PARTS & SERVICE NEWS

REF NO.	AT04275
DATE	November 27, 2004

SUBJECT: PROCEDURE TO ACCOMMODATE THE PARTS THAT ENHANCE THE RELIABILITY OF 2ND CLUTCHES

APPLICATION: GD555-3A: 10001-11057
 GD555-3C: 50001-51044
 GD655-3: 1001-1002
 GD655-3A: 10001-11027
 GD655-3C: 50001-51091
 GD655-3Y: 4001-4104
 GD655-3Y: 4106-4106
 GD675-3A: 10001-11017
 GD675-3C: 50001-51011

Fig. 1

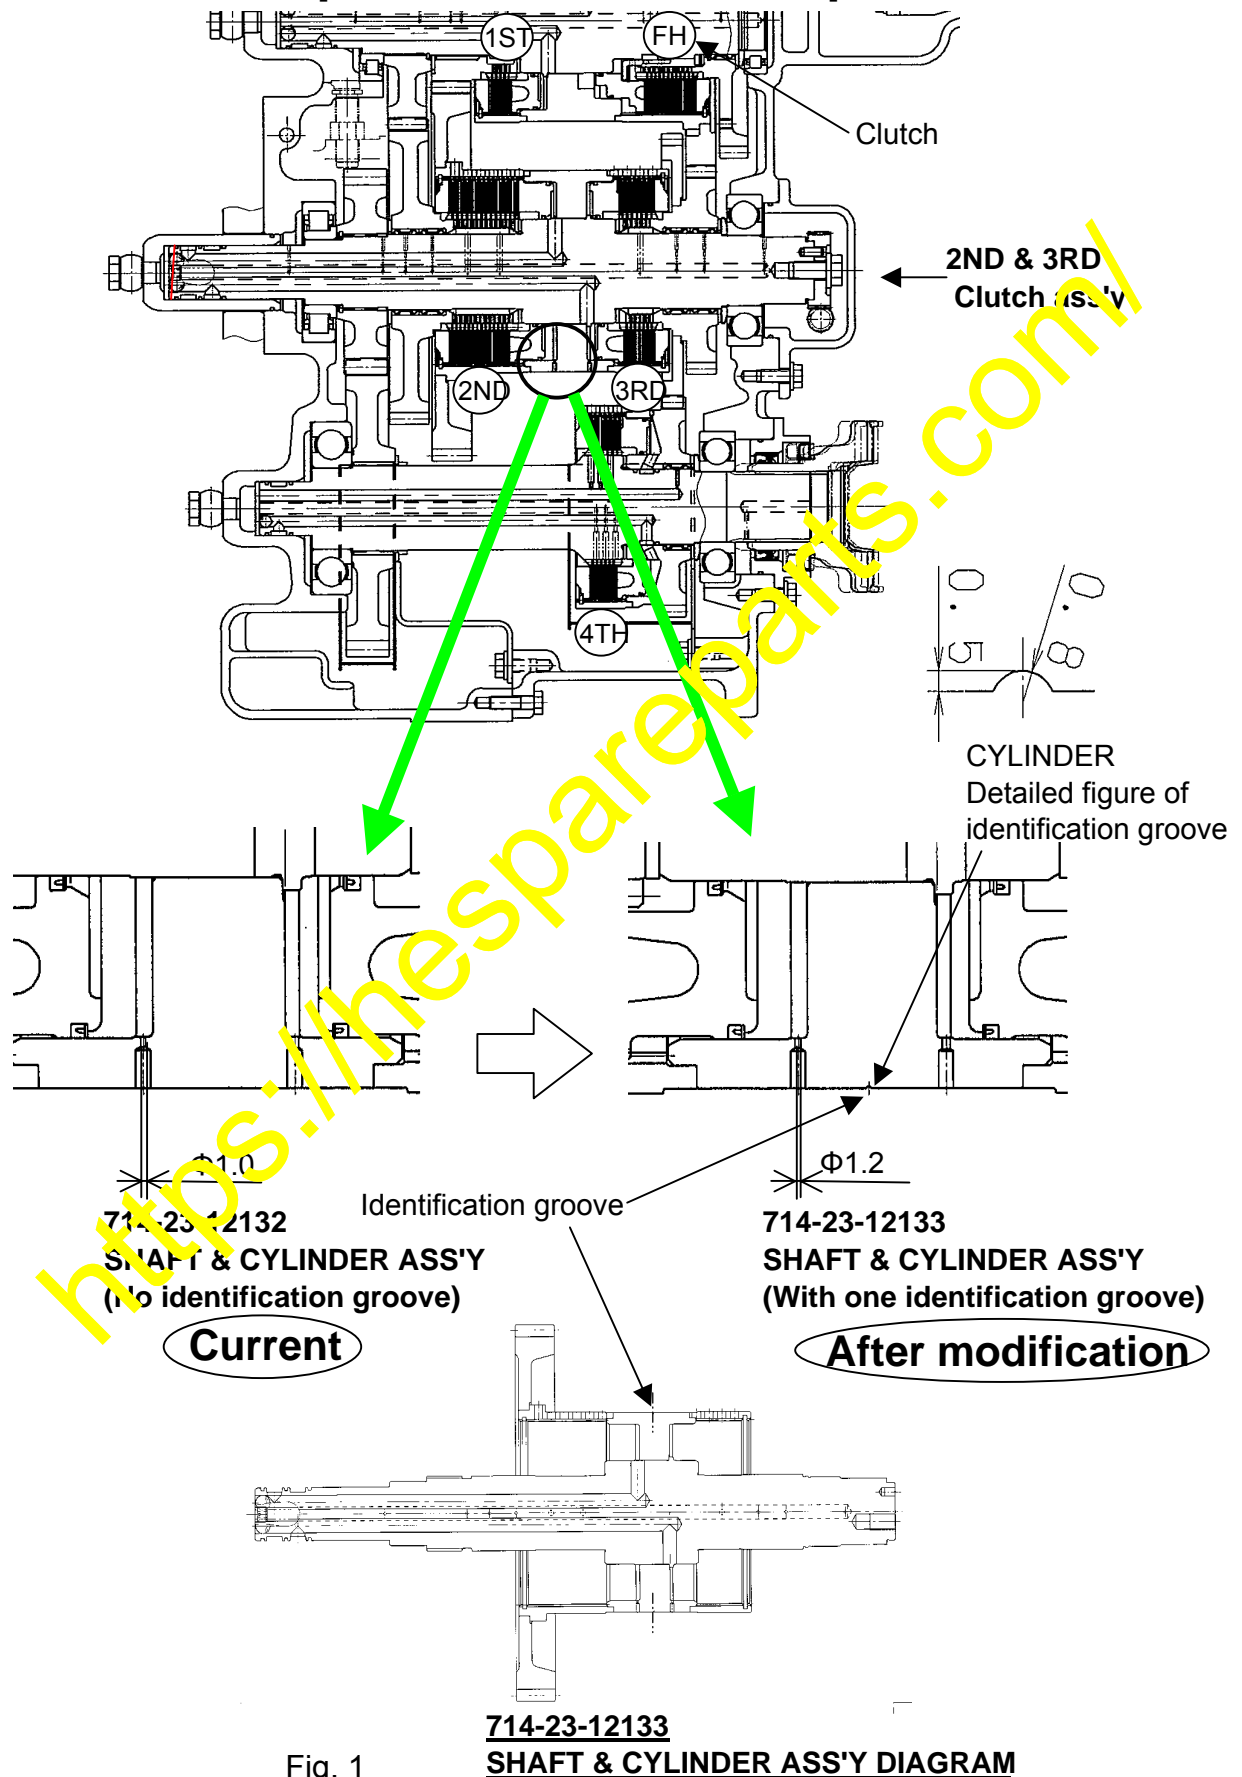
The oil drainage speed of the second clutch has been increased by enlarging the bleed off diameter (see Fig.1) from $\Phi 1.0$ to $\Phi 1.2$.

Transmission piping diagram

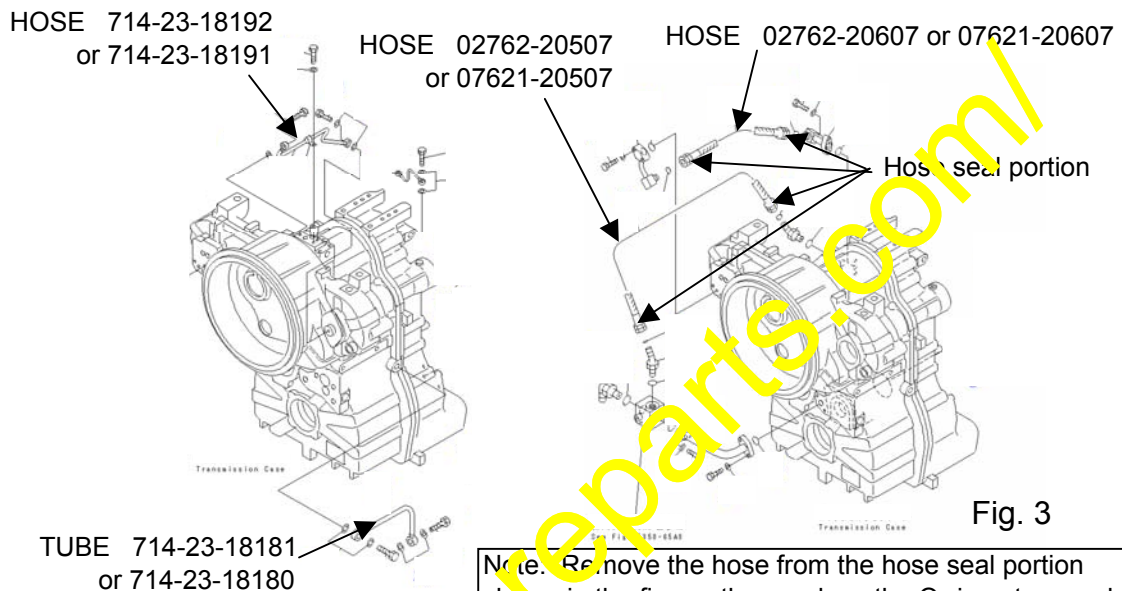
Note: Remove the hoses and tubes below for respective transmission ass'y.

- (1) Transmission ass'y: 714-23-10020

Remove only the four parts: hoses (02762-20607 and 02762-20507) and tubes (714-23-18181 and 714-23-18192). Do not remove other tube/valve ass'y.

- (2) Transmission ass'y: 714-23-10000

Remove only the four parts: hoses (07621-20607 and 07621-20507) and tubes (714-23-18180 and 714-23-18191). Do not remove other tube/valve ass'y.

Fig. 5

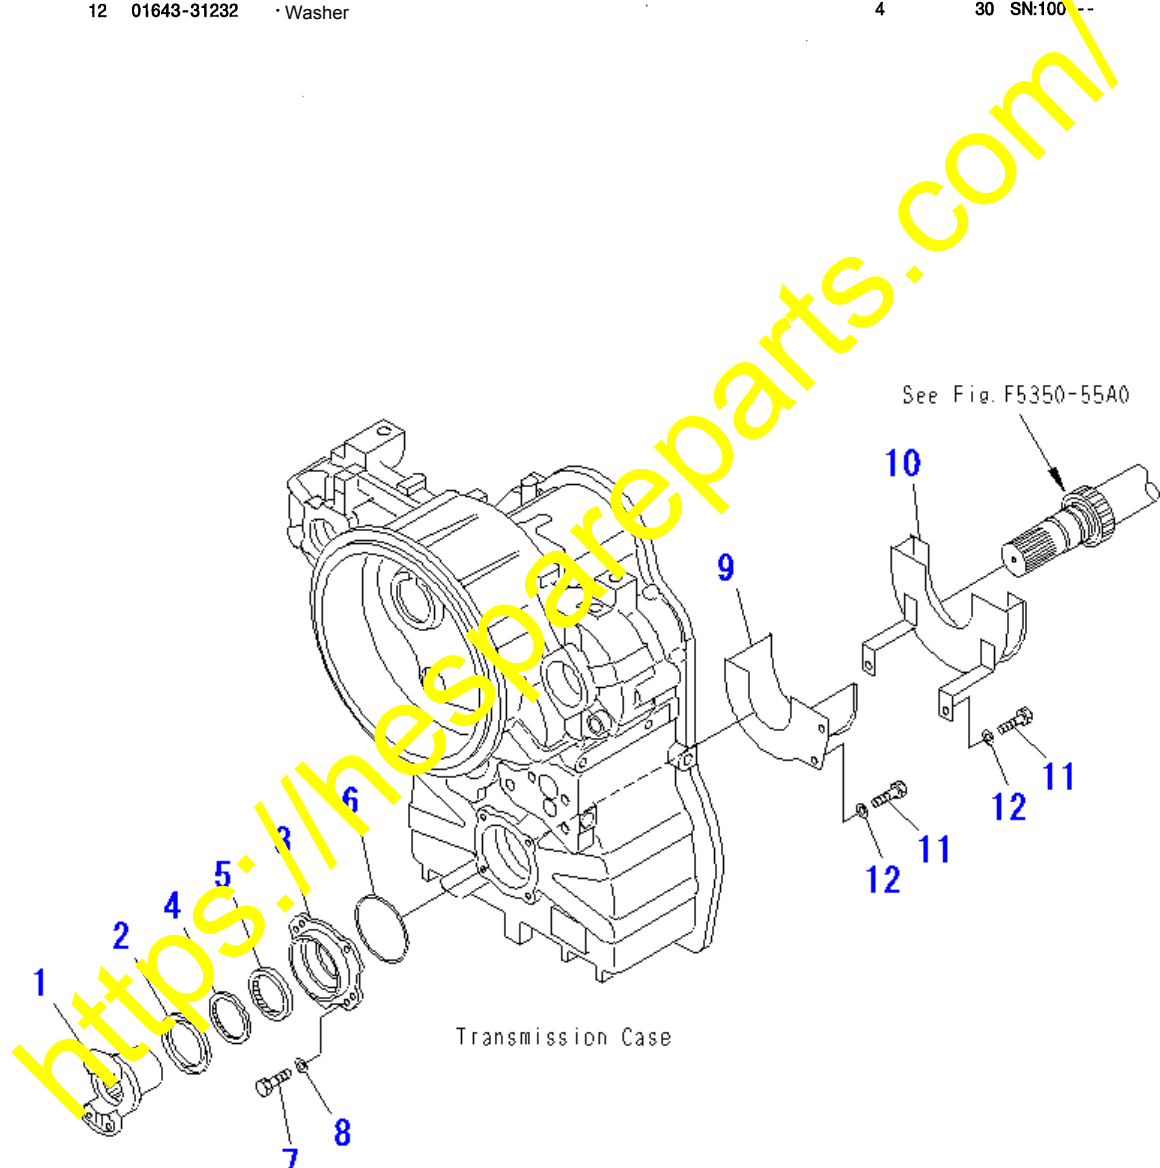
(Replaced with a new one)
(Replaced with a new one)
(Replaced with a new one)

Fig. 6

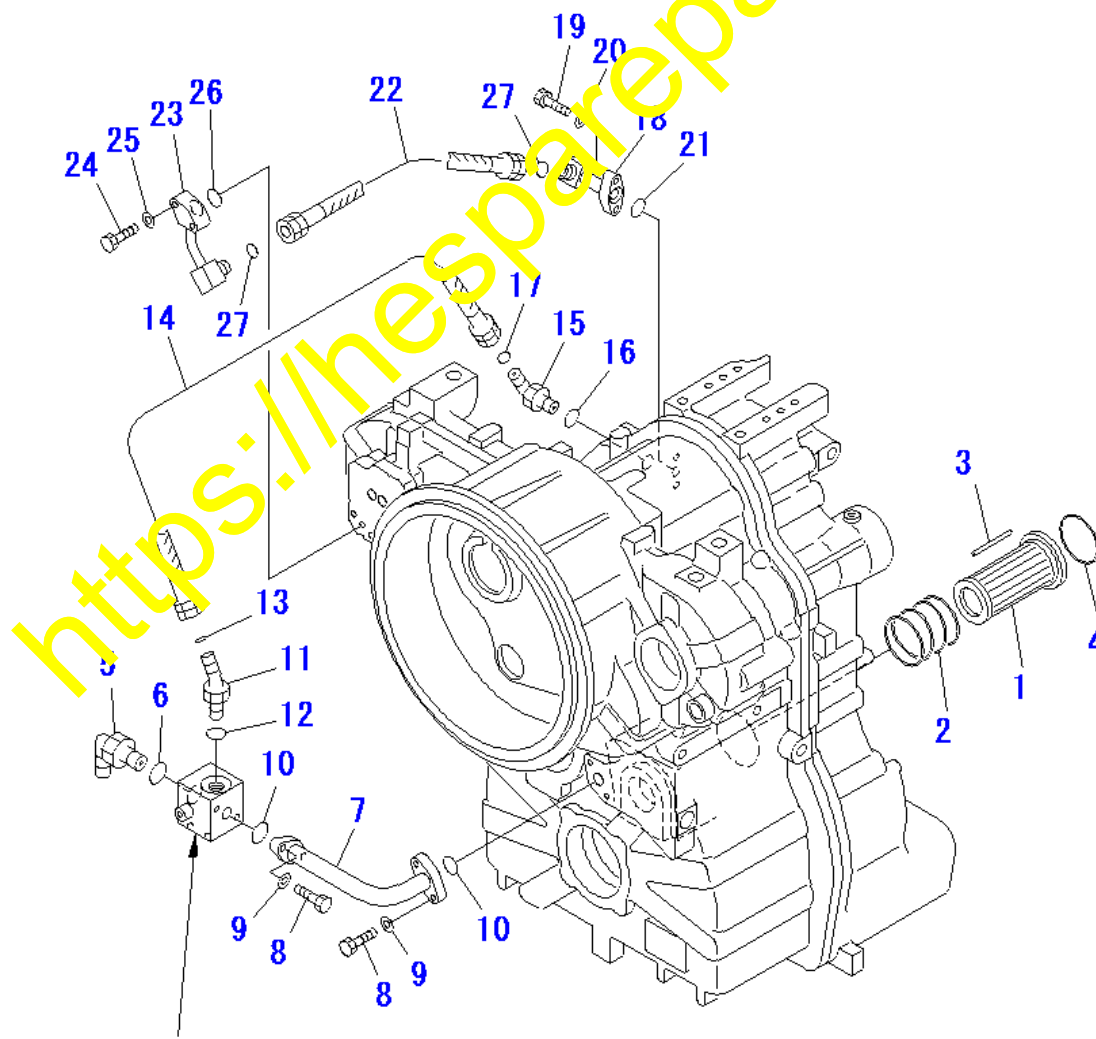
For transmission assembly (Part No. 714-23-10000), no O-ring is required because a taper seal is used for a hose.

Fig. 7

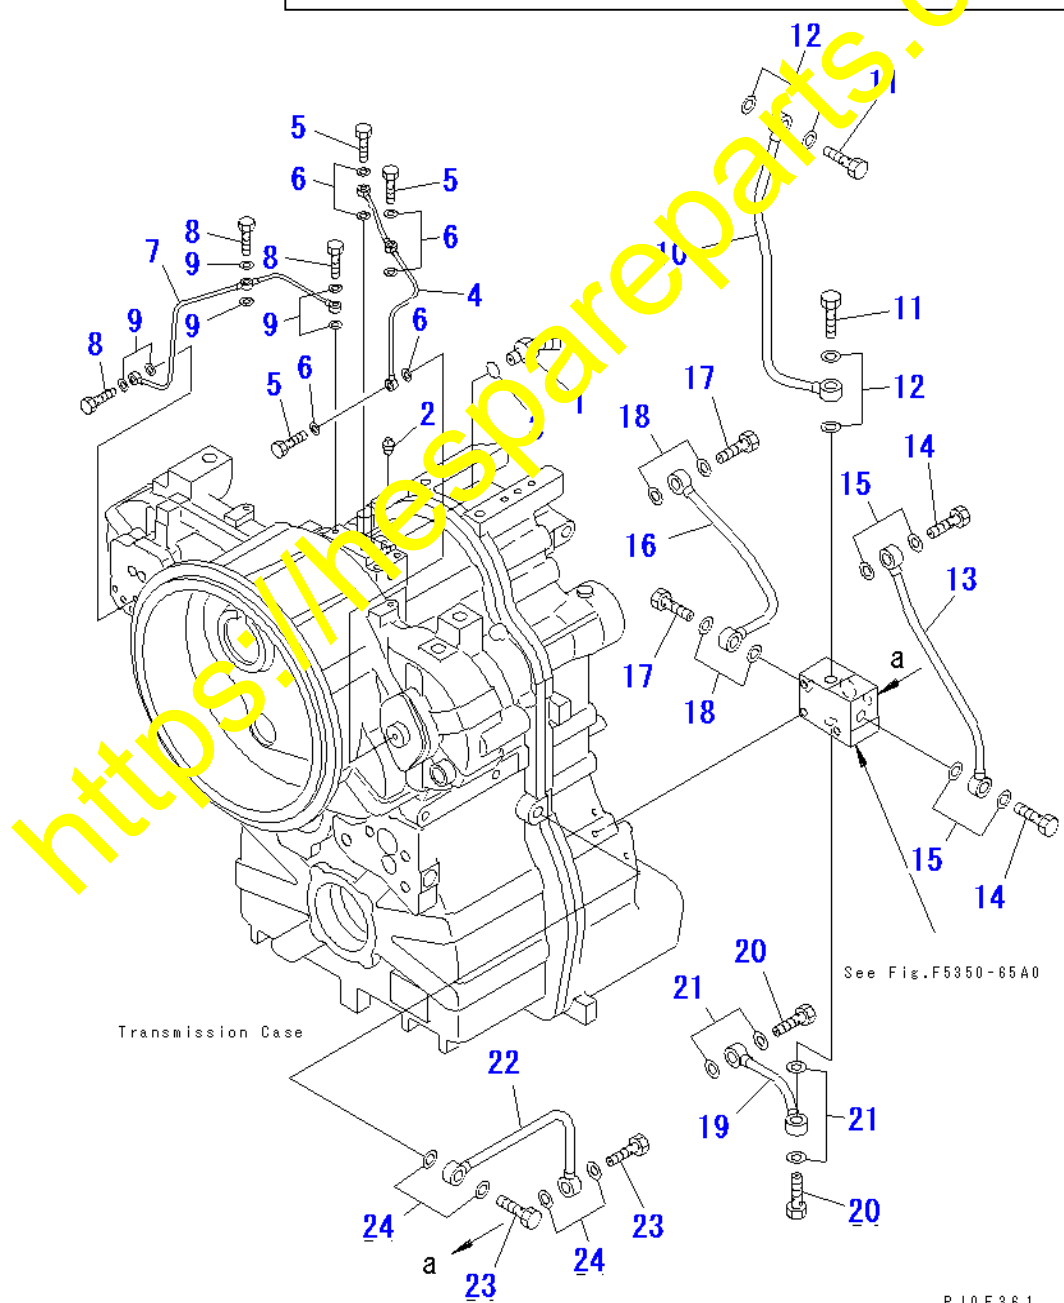
Gasket: Part No. 07005-02416 for transmission ass'y: Part No. 714-23-10020
 Gasket: Part No. 07005-02012 for transmission ass'y: Part No. 714-23-10000

Fig. 8

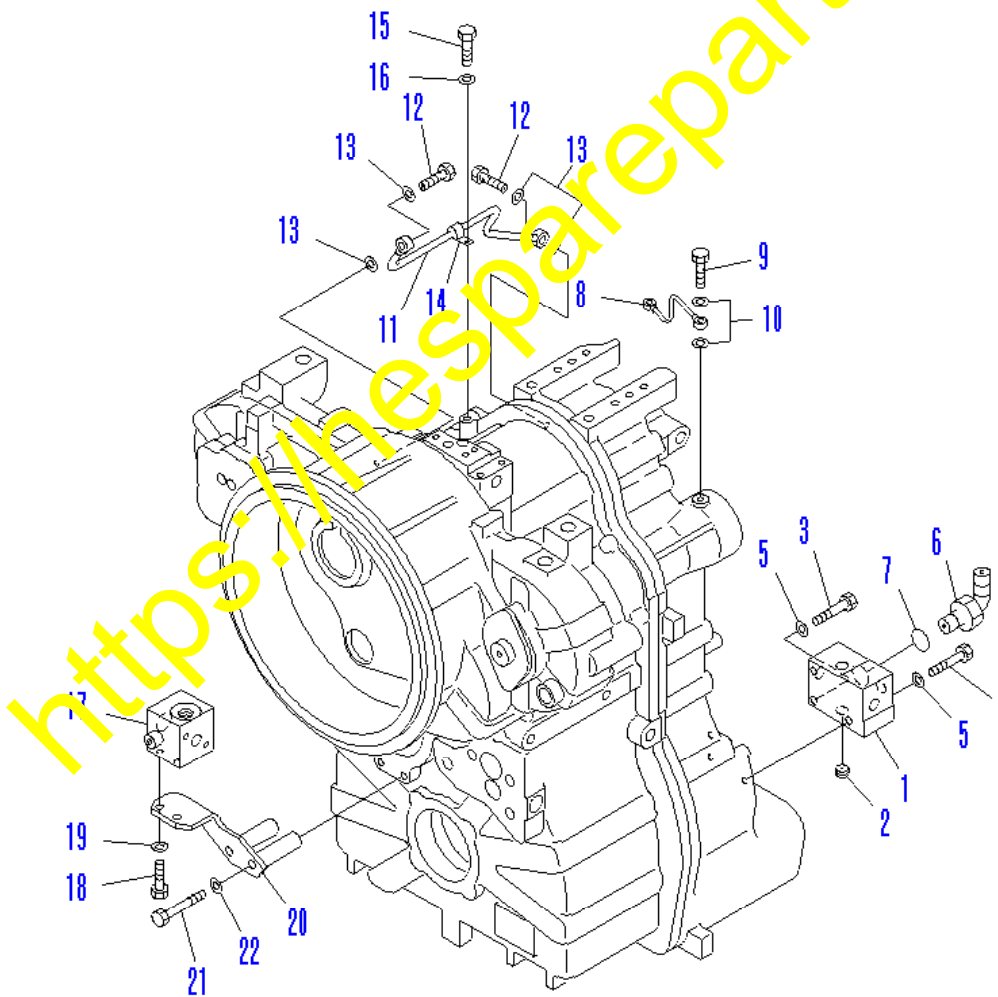
Gasket: Part No. 07005-01612 for transmission ass'y: Part No. 714-23-10020 Q'ty 4
 Gasket: Part No. 07005-01612 for transmission ass'y: Part No. 714-23-10000 Q'ty 2
